SUBJECT: Application for amend to License DPR-31 & DPR-41 revising
 Tech Specs to reflect results of ECCS analysis on power
 distribution limits for steam generator tube plugging level
 of 25%.Supplements 800213 amend request.

Re: Turkey Point Units 3 and 4
Docket Nos. 50-250 and 50-251
Proposed Amendment to Facility
Operating Licenses DPR-31 and DPR-41

Figure 3.2-3b

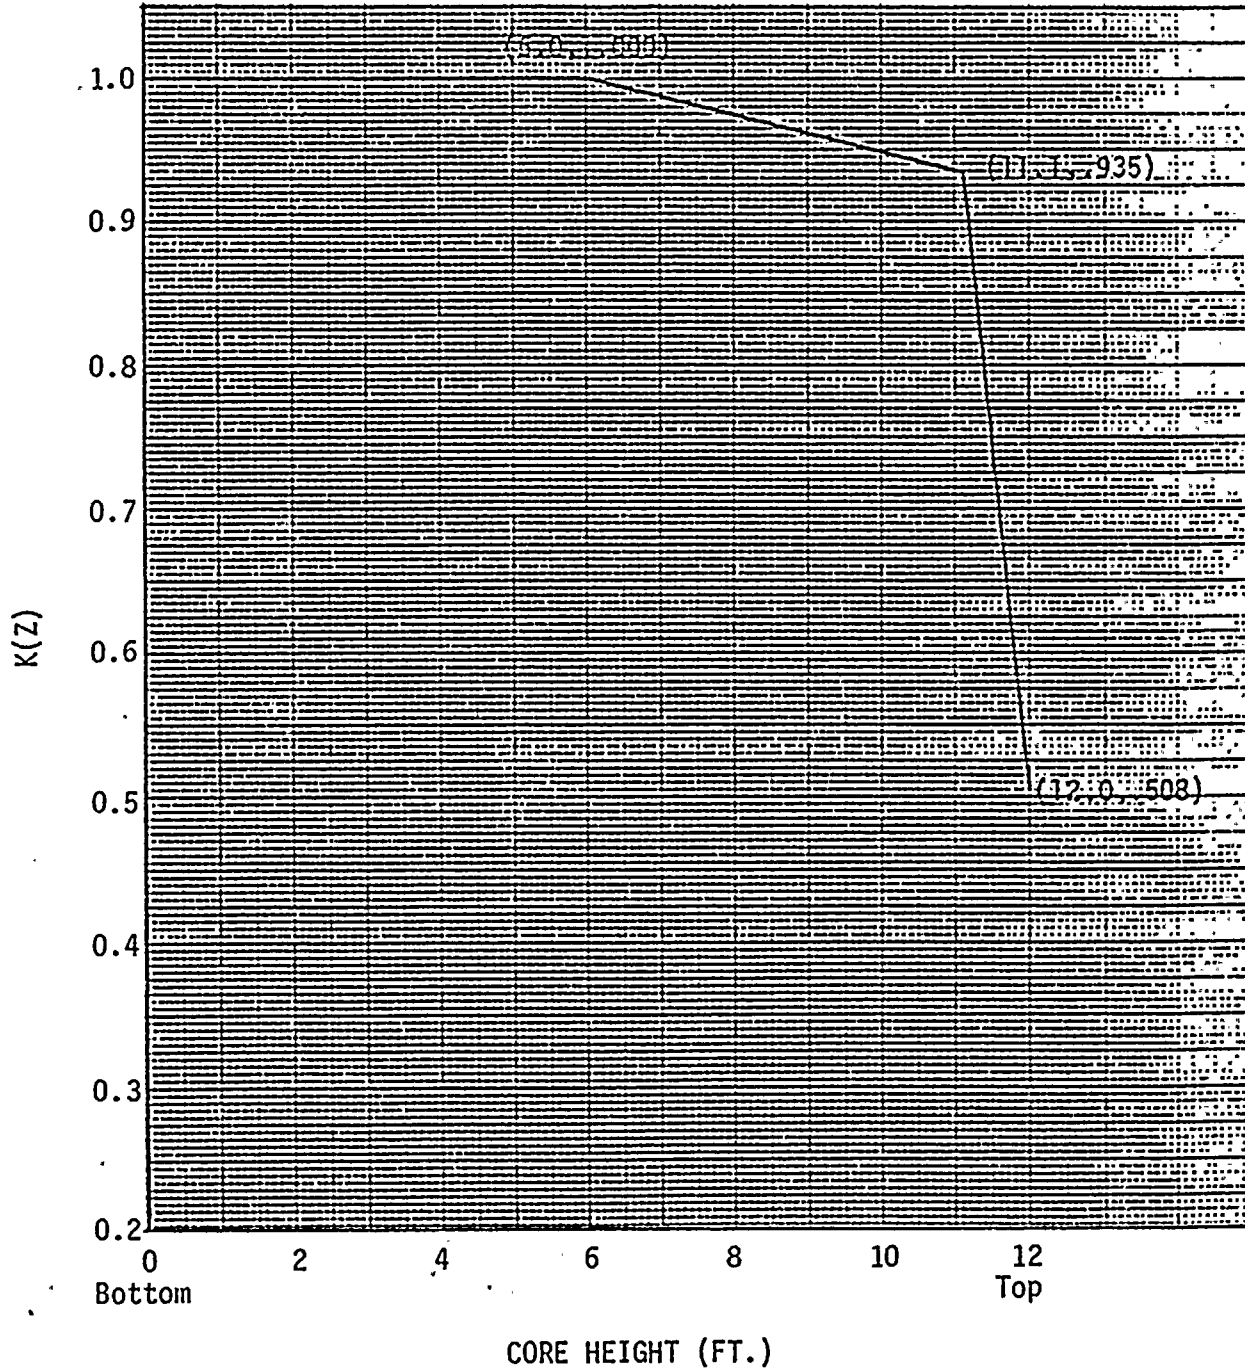
The normalized hot channel factor operating envelope for a steam generator tube plugging level of 25% is revised to reflect the results of a recent ECCS analysis.
